**REVISION 002 TO  
REQUEST FOR QUOTATION**

<b>Title:</b> Snow Removal Services- Parks Canada Collections and Curatorial Centre	
<b>Solicitation No.:</b> 5P300-23-0113/A	<b>Date:</b> October 23, 2023
<b>Amendment No.:</b> 002	
<b>Client Reference No.:</b> N/A

## Amendment 002

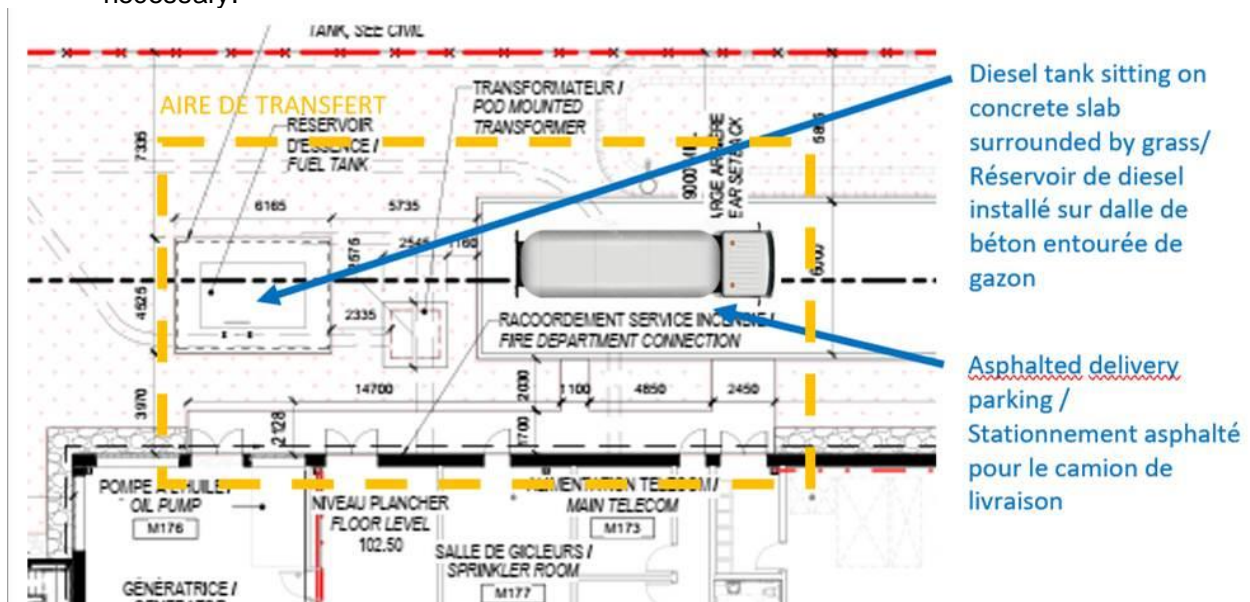
**Q2.** On the map, 2 sidewalks are indicated leading to the main entrance, but in reality, there is only one. Also, there is a zone in front of the yellow facade that is currently planted. Will the landscaping stay that way or will there be an additional sidewalk closer to the building?

**A2.** There has been a modification during construction. Update landscaping drawing is attached.
